St. Lucie Units 1 and 2
Docket Nos. 50-335 and 50-389

Florida Power & Light (FPL)/St. Lucie's Third Overall Integrated Plan Status Report in Response to March 12, 2012 Commission Order Modifying Licenses with Regard to Requirements for Mitigation Strategies for Beyond-Design-Basis External Events (Order Number EA-12-049)

Third Six Month Status Report for the Implementation of Order EA-12-049, Order Modifying
Licenses with Regard to Requirements for Mitigation Strategies for Beyond-Design-Basis
External Events

Figure 24 Connections for Diesel Oil Gravity Drain Connections from Unit 2 Diesel Oil Storage Tanks (Rev 0)

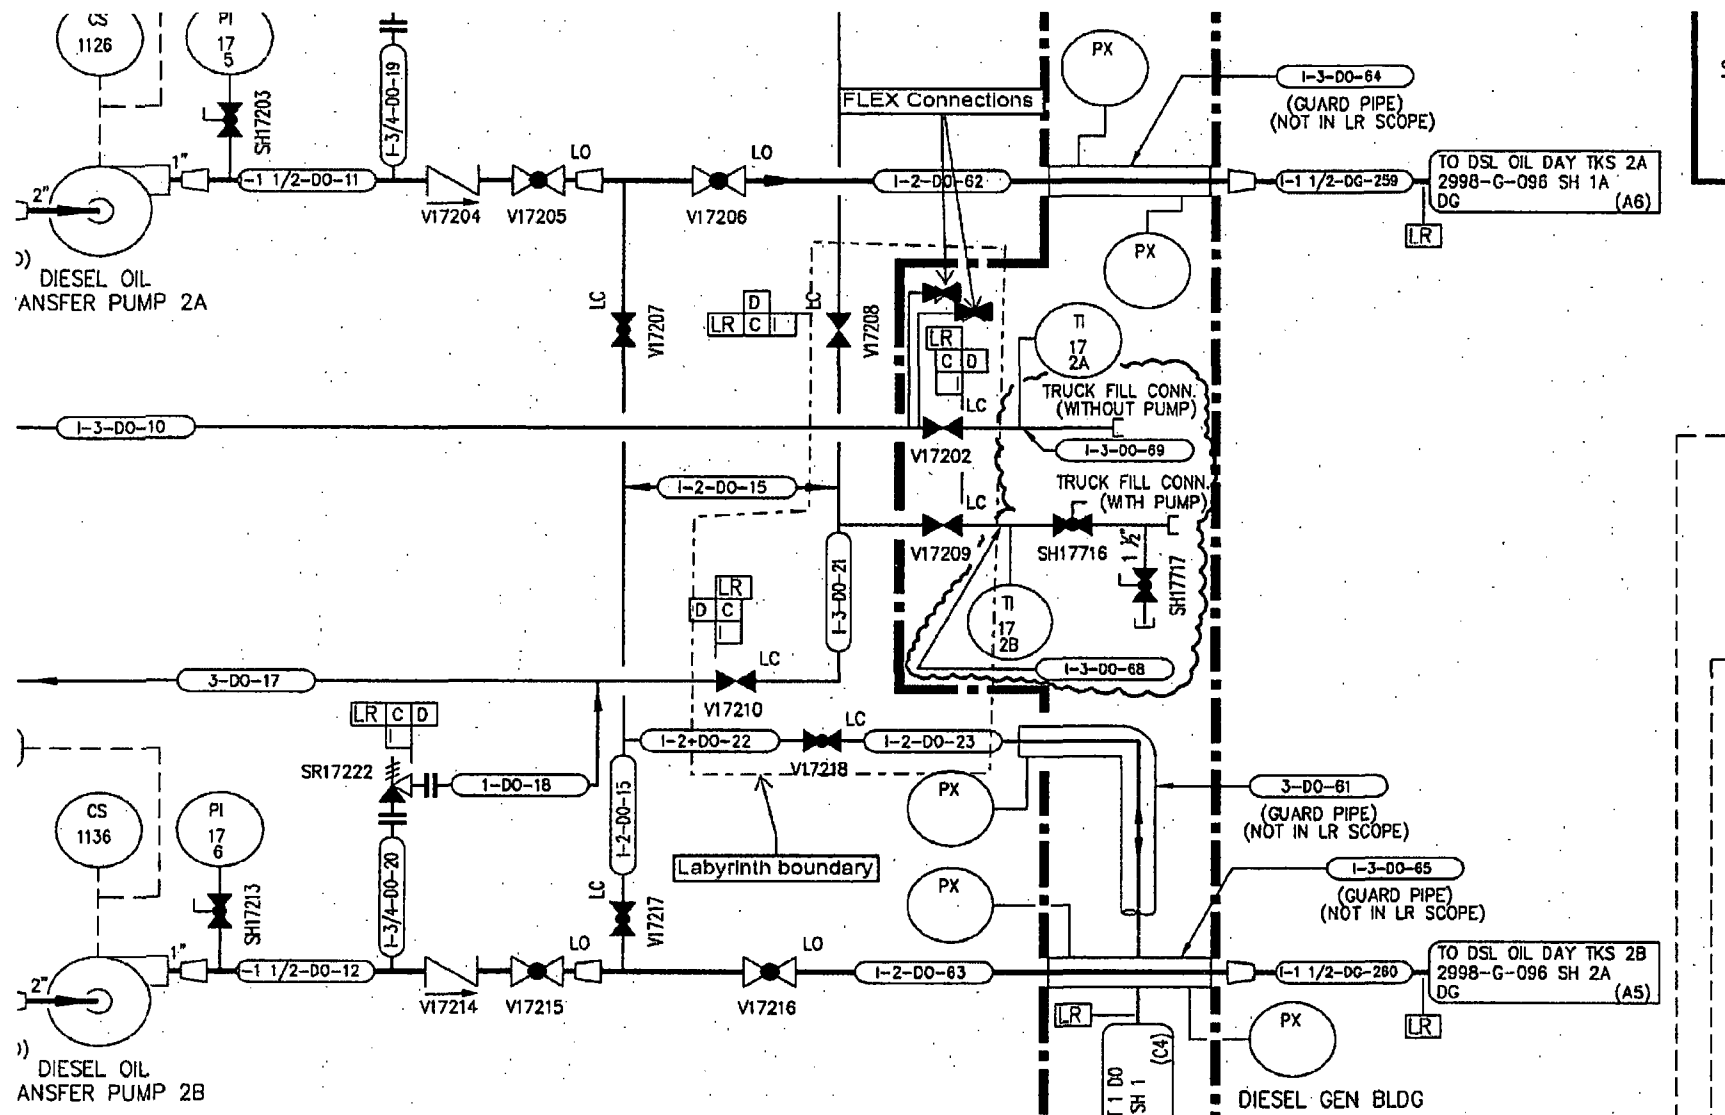
Note that the Reference 1 FLEX response stated the refueling of diesel fuel oil driven equipment will be accomplished via a trailer stored in the FESB, on which will be mounted a 500-gallon tank. The tank size has been evaluated and a 1000 gallon trailer mounted tank is being procured. Gravity fill of this tank has been revised to use V17202 or one of two new redundant valves to be installed on the fill line. See new Figure 24.
